APPLICATION NO.	FILING DATE	FIRST NAMED INVENTOR	ATTORNEY DOCKET NO.	CONFIRMATION NO.
10/758,001	01/16/2004	Eugenio Cruz Garcia	5724.012.21-US	5034
30827	7590	05/05/2005		
MCKENNA LONG & ALDRIDGE LLP 1900 K STREET, NW WASHINGTON, DC 20006				
			EXAMINER GREEN, CHRISTY MARIE	
			ART UNIT 3635	PAPER NUMBER

Office Action Summary

This is a first office action for serial number 10/758001, entitled New Direct laminated Door, filed on January 16, 2004.

Fig. 1.

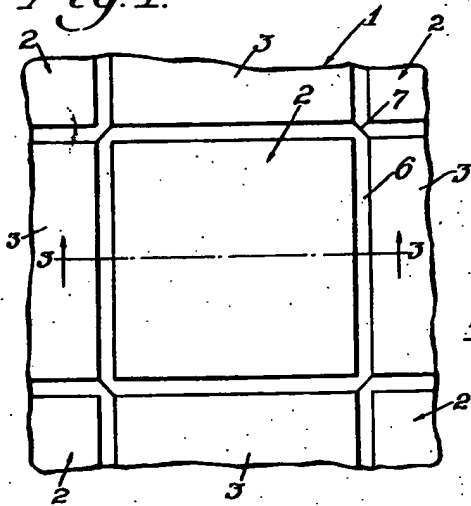
Johnston teaches that it is known in the art to provide a composition of sheets or tile that are mechanically pressed (page 2, column 2, lines 69-70) and cut into a product (page 2, column 2, lines 12-13), the product includes a surface (at 2, figure 1) with both a perimeter area (attached figure 2) having an edge contour (attached figure 3) and an interior region (at 6 – figure 2), where the perimeter area is relieved such that a portion of the edge contour is below the interior region (attached figure 2), a surface texture that varies in accordance with the visual pattern (page 2, column 1, lines 28-34), where the surface (at 2 – figure 1) is formed having a visual pattern (at 15, figure 8 or figure 2) that imitates another product (interpreted to be rough hewn stone or pitted stone – page 2, column 1, lines 29-33), and the edge contour is machined (interpreted to be cut at 7, figure 2, page 2, column 1, lines 13-15); the edge contour has a substantially linear cross-sectional shape (shown in figures 2 and 3) extending from the interior region (at 6 – figure 2) to the edge of the product (attached figure 2; the machining of the edge contour comprising mechanical scraping, milling or cutting (page 2, column 1, lines 13-15); the visual pattern (at 2a and 3a) on the surface extends (shown in figures 1 and 1a)/does not extend (shown in figure 6) into the edge contour; and the surface of the edge contour exposes the interior of the laminated material (“2” – at edge contour in attached figure 3). It would have been obvious to one having ordinary skill in the art at the time the invention was made to provide the elements of the composite sheets as
